# Access Compliance Report

## Public Rights-of-Way

Intersection ID: 11660	Main Street: E_20TH_ST	Cross Street: HARRILL_ST	Location: NW
ADA ID: 4B9788EE4862	Ramp Type: PerpDiag	Initial Pass/Fail: Fail	Overall Compliance: No
		Severity Score: 60

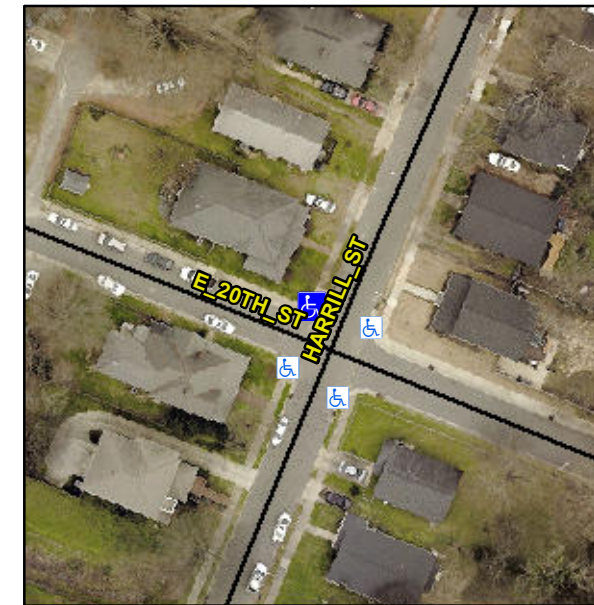
**Not Found, R304.5.1, R304.2.2**

Compliance	Description	Data	Compliance	Description	Data
N/A	Ramp Length (in)	56.0	No	Ramp Slope (%)	13.3
No	Ramp Width (in)	31.0	Yes	Ramp XSlope (%)	0.8
N/A	Flare Type LT	N/A	N/A	Flare Type RT	N/A
N/A	Flare Slope LT (%)	N/A	N/A	Flare Slope RT (%)	N/A
N/A	Flare Traversable LT?	N/A	N/A	Flare Traversable RT?	N/A
N/A	Landing Length (in)	N/A	N/A	DWS Provided?	N/A
N/A	Landing Width (in)	N/A	N/A	DWS Contrast?	N/A
N/A	Landing Slope (%)	N/A	N/A	DWS Length (in)	N/A
N/A	Landing X Slope (%)	N/A	N/A	DWS Full Width?	N/A
N/A	Landing Curb? (Y/N)	N/A	N/A	DWS Offset (in)	N/A
N/A	Shared Landing?	N/A			
N/A	Gutter Ponding?	N/A	N/A	Gutter Slope (%)	N/A
N/A	Gutter Lip Ht (in)	N/A	N/A	Gutter X Slope (%)	N/A
N/A	Painted X Walk1?	No	N/A	Painted X Walk2?	No
	X Walk 1 Direction	To SE		X Walk 2 Direction	To SW
N/A	X Walk 1 Width (in)	N/A	N/A	X Walk 2 Width (in)	N/A
	X Walk 1 Slope (%)	3.4		X Walk 2 Slope (%)	2.2
	X Walk 1 X Slope (%)	0.0		X Walk 2 X Slope (%)	2.9

**Remove & Replace Curb Ramp With Two New Directional Ramps or Equivalent.**
